Subject: **WATTS BAR NUCLEAR PLANT (WBN) UNIT 2 - RESPONSE TO
LARGE BREAK LOSS OF COOLANT ACCIDENT (LBLOCA) AND
OVER-PRESSURIZATION REQUEST FOR ADDITIONAL
INFORMATION**

Watts Bar Unit 2 (WBT) Responses to Request for Additional Information (RAI) – BE LOCA Data for Transmittal to NRC

**WATTS BAR NUCLEAR PLANT UNIT 2
WATTS BAR UNIT 2 LOSS OF LOAD RESULTS
WITH NO CREDIT FOR THE FIRST SAFETY GRADE TRIP**

Figure 10. Watts Bar Nuclear 2: Predicted ECCS flow for one of 3 loops injecting (includes accumulator injection).

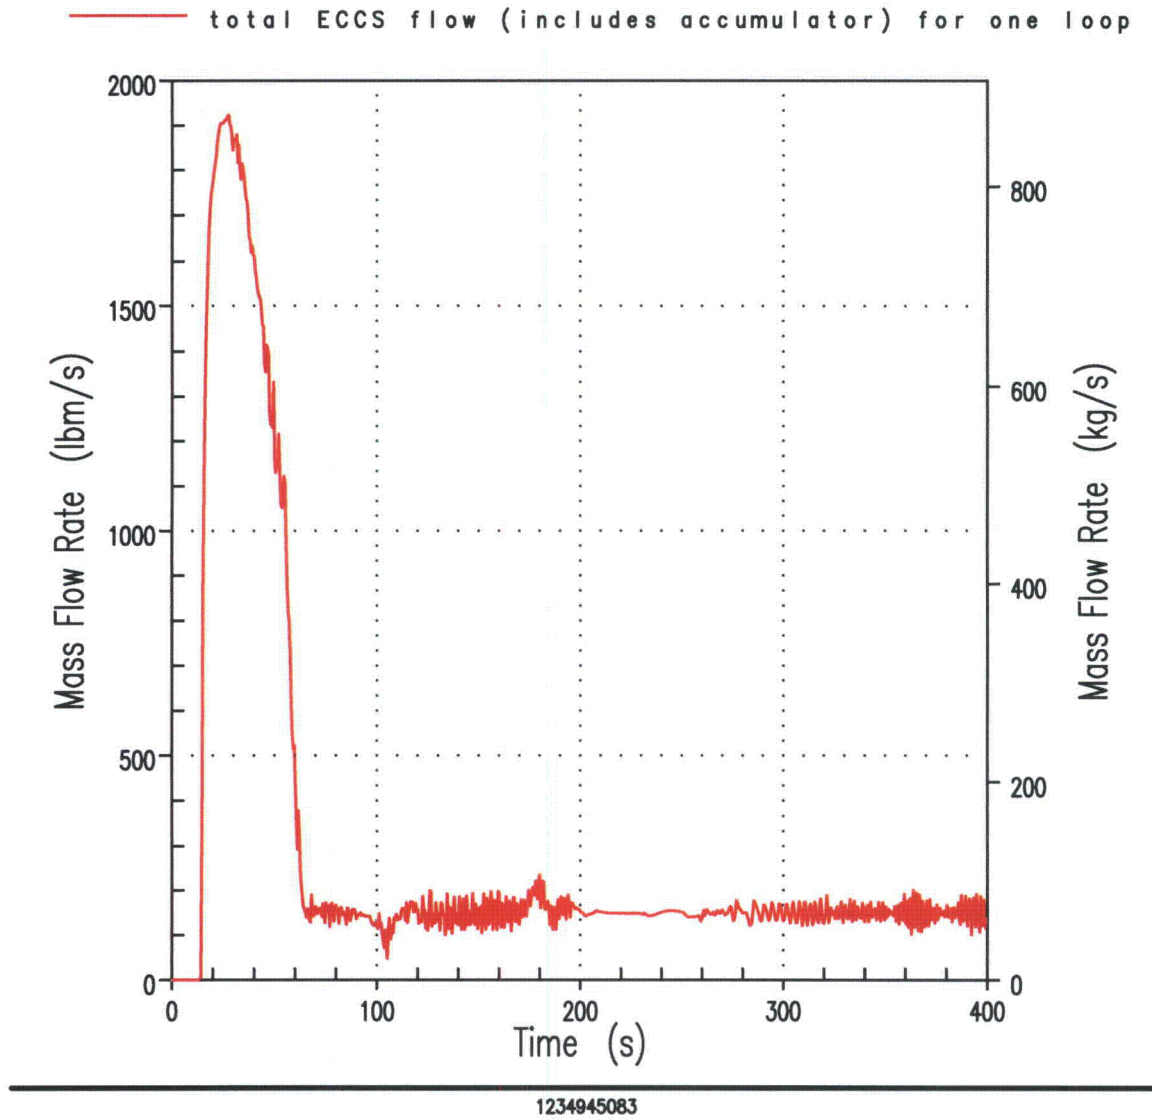
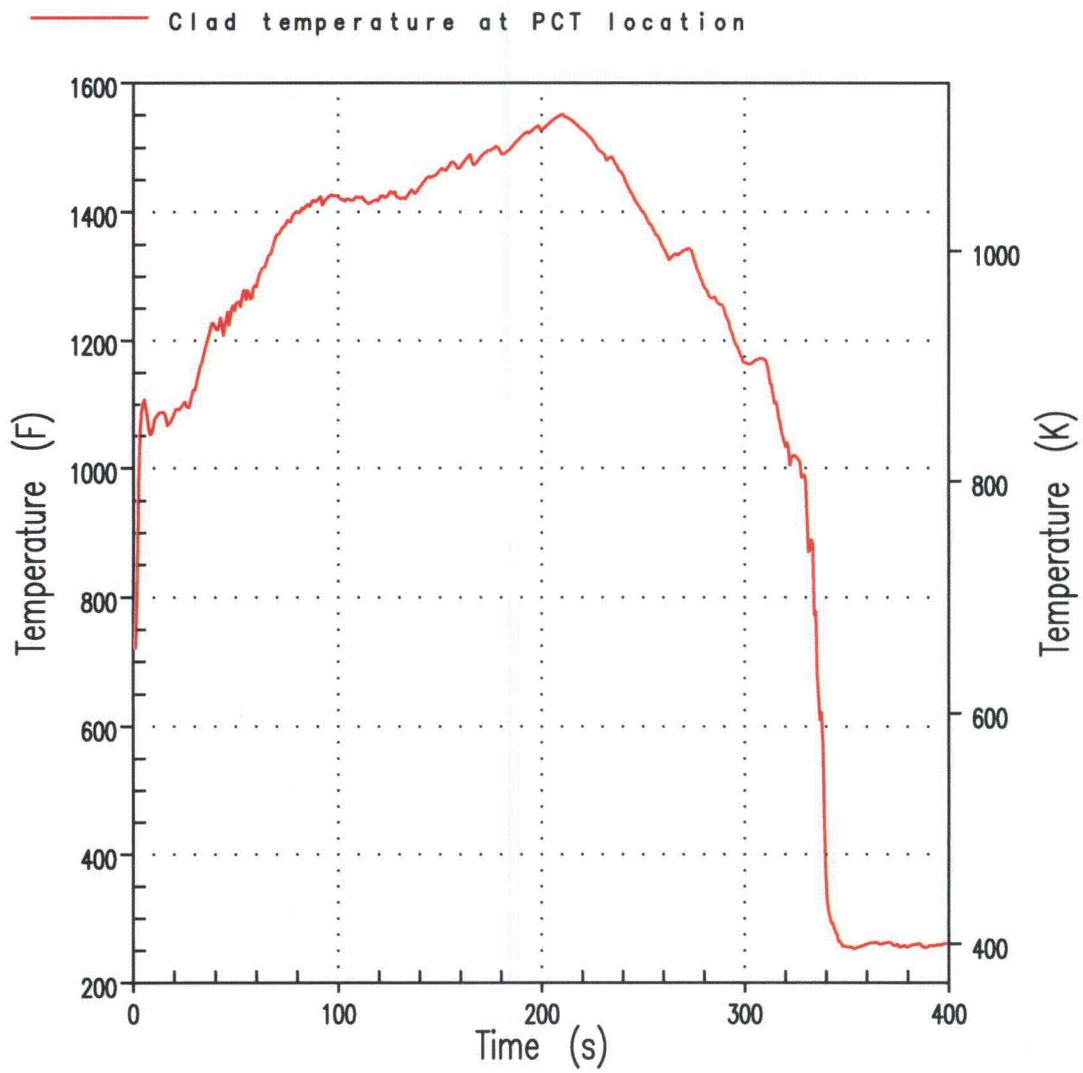
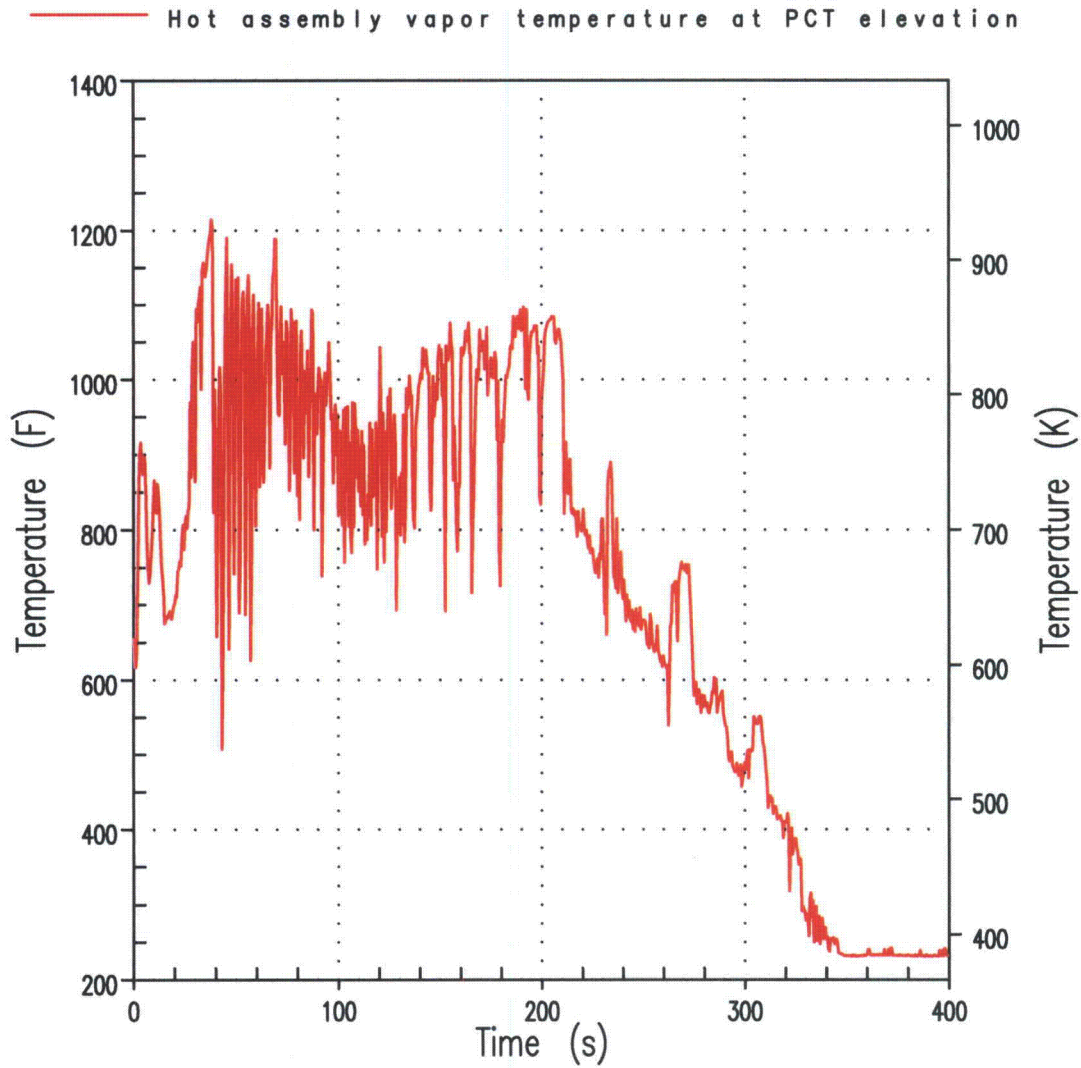
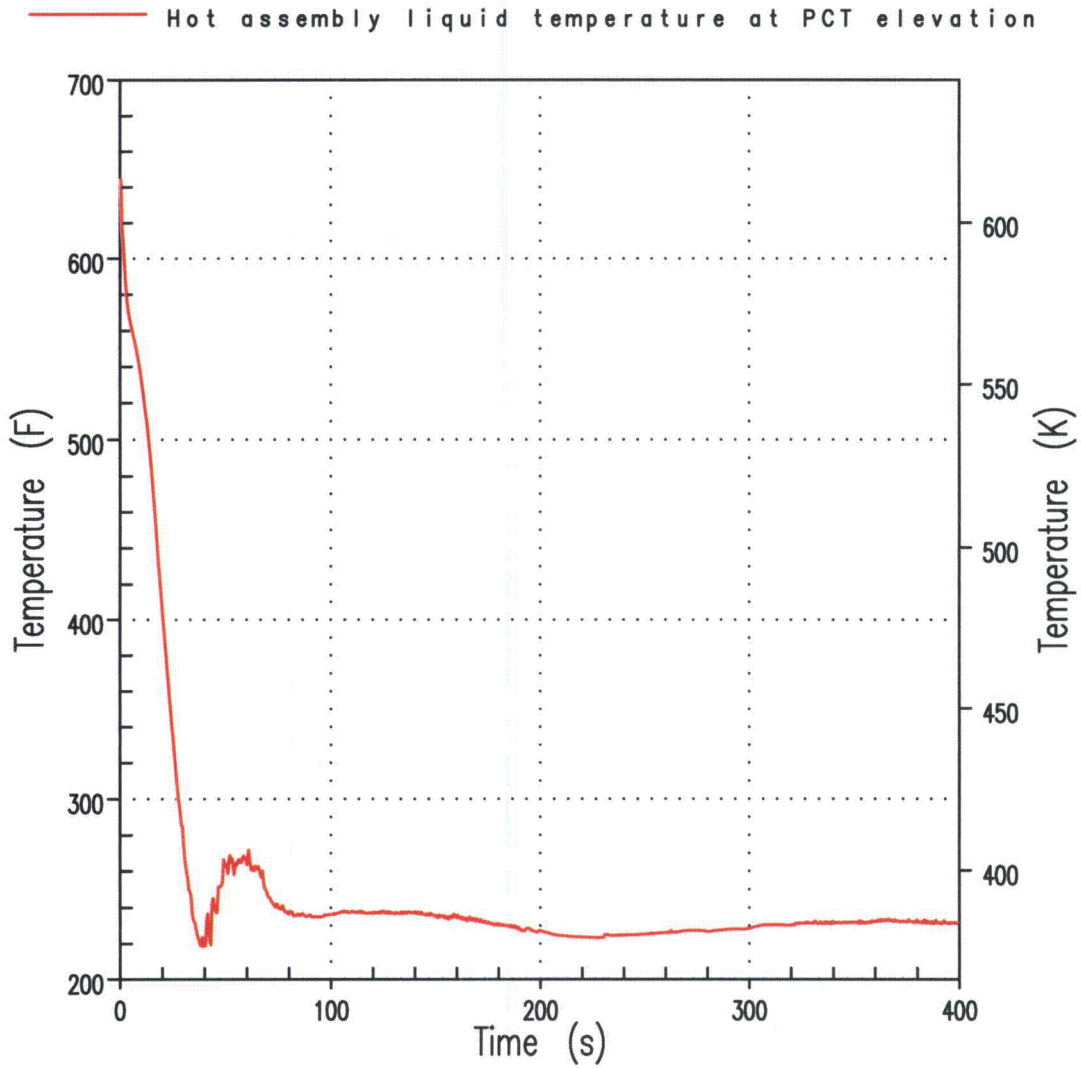
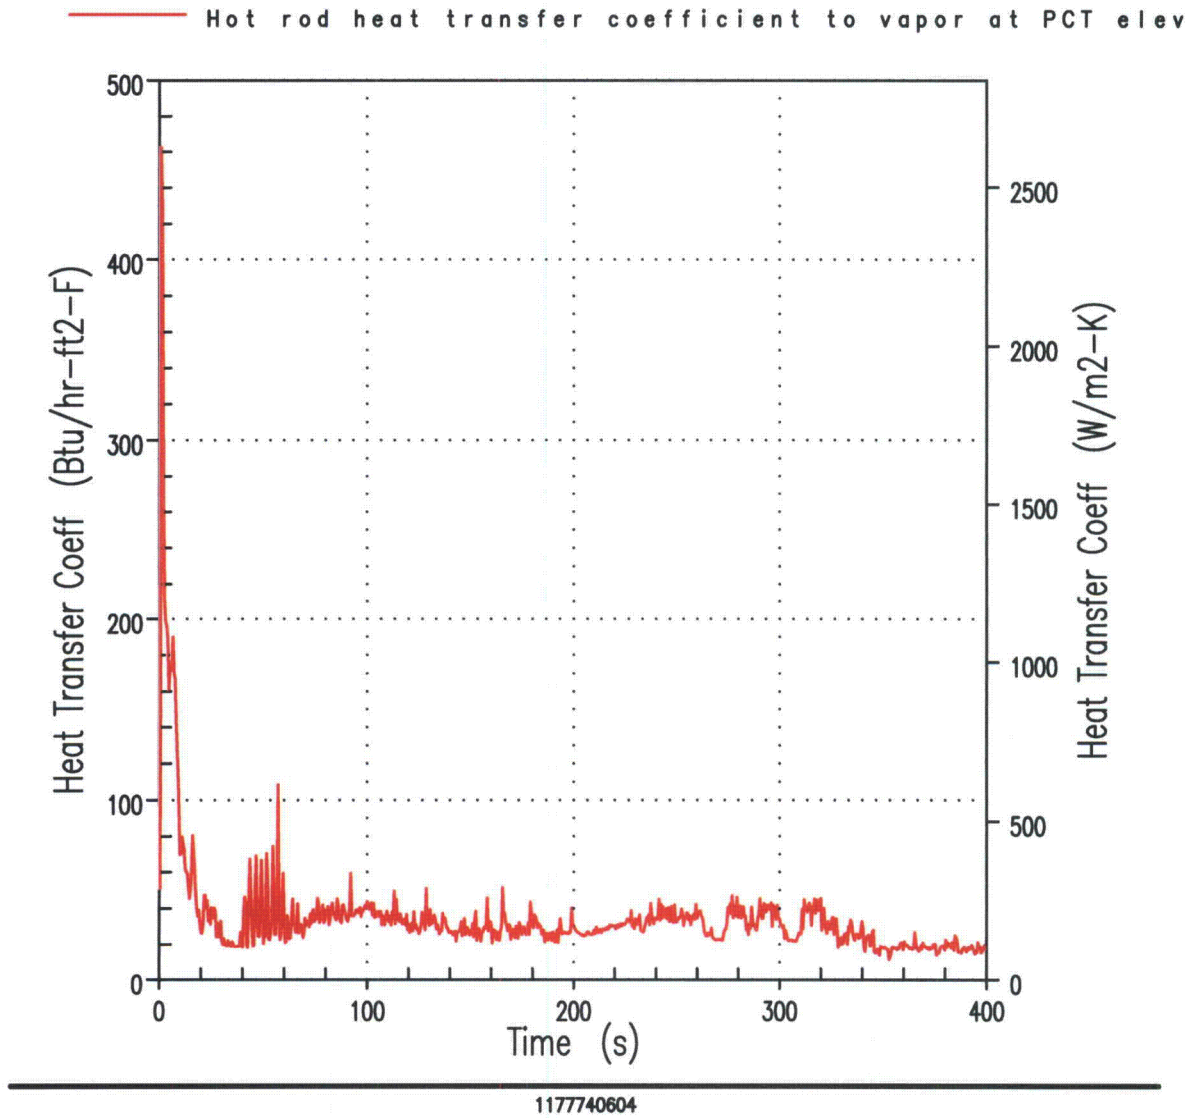
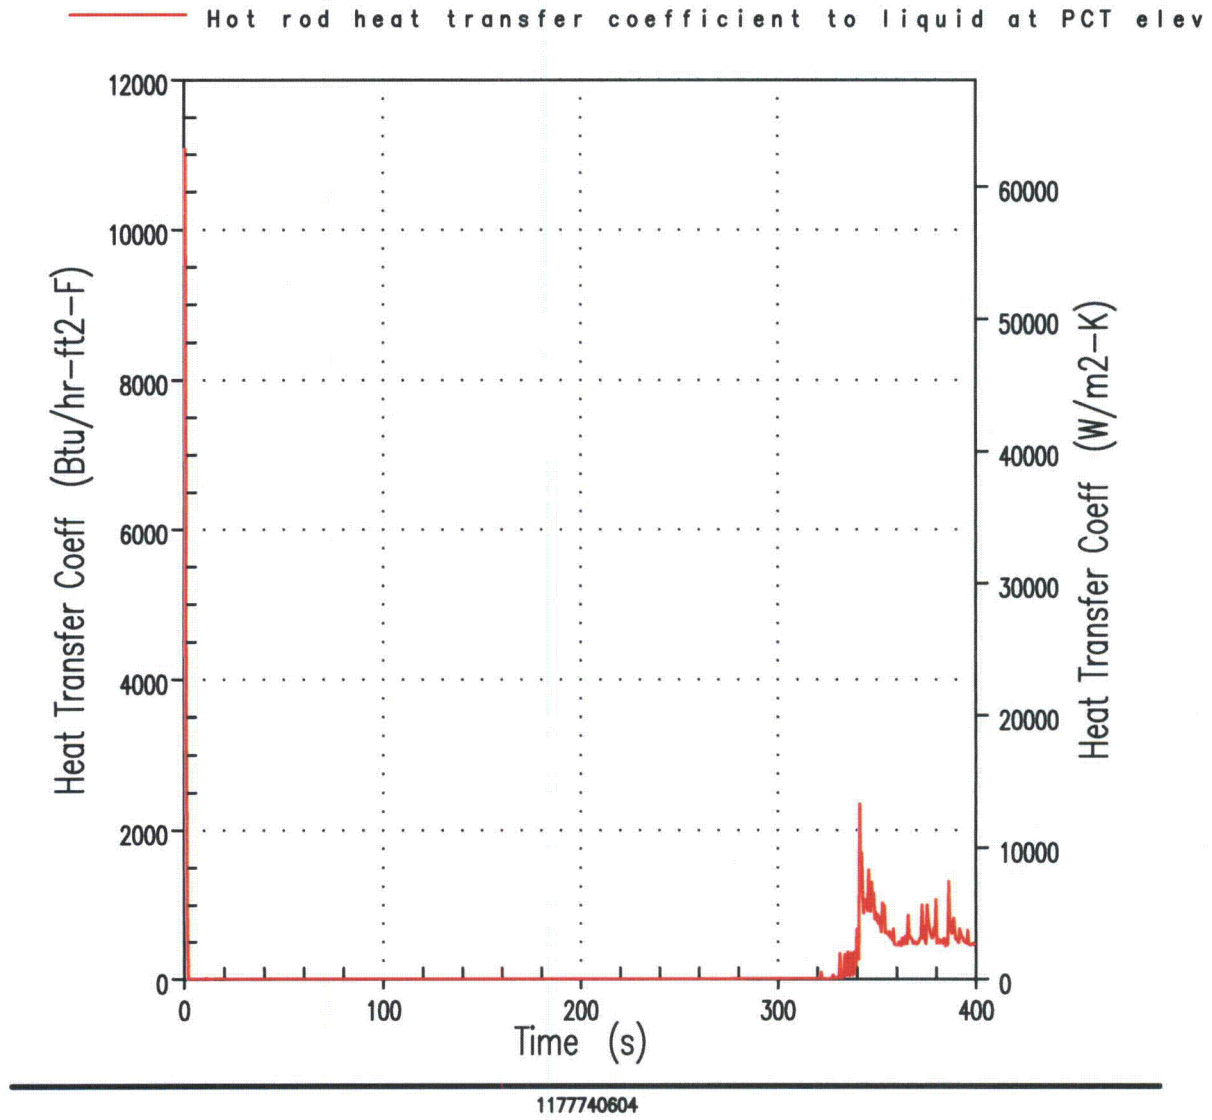
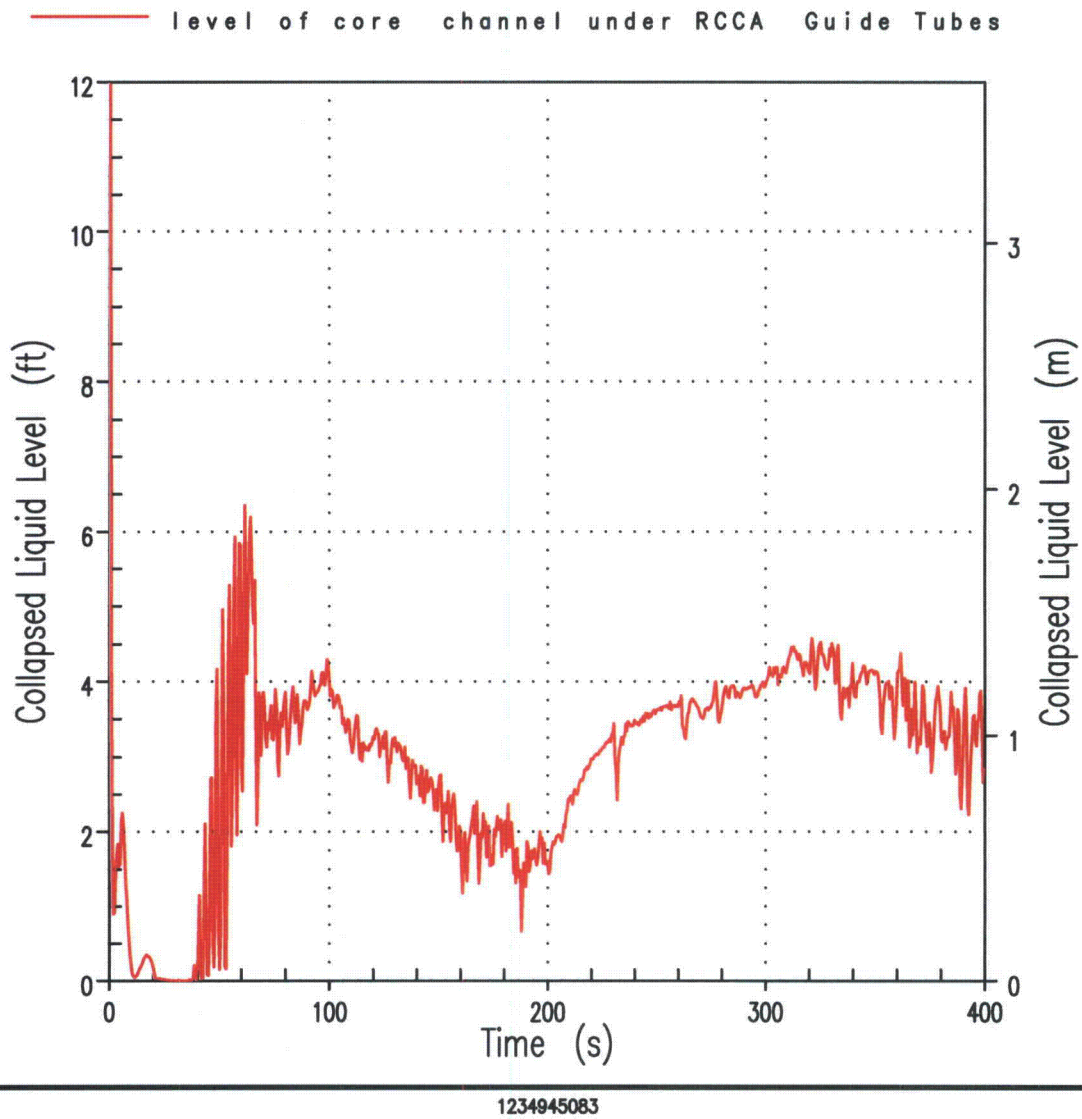
RAI 4: Provide the following data:

Downcomer level
RCS pressure
Fluid temperatures in downcomer
Containment Pressure
ECCS flow
Peak clad temperature (PCT)
Fluid temperatures at the PCT location
Heat transfer coefficients at the PCT location
Core level

Requested data are provided in Figures 3 through 16. Note that PCT plot is from the hot rod (HOTSPOT) calculation. The PCT location is at elevation 2926 mm (115.2 in) above bottom of fuel. Other plots are from the WCOBRA/TRAC calculation.
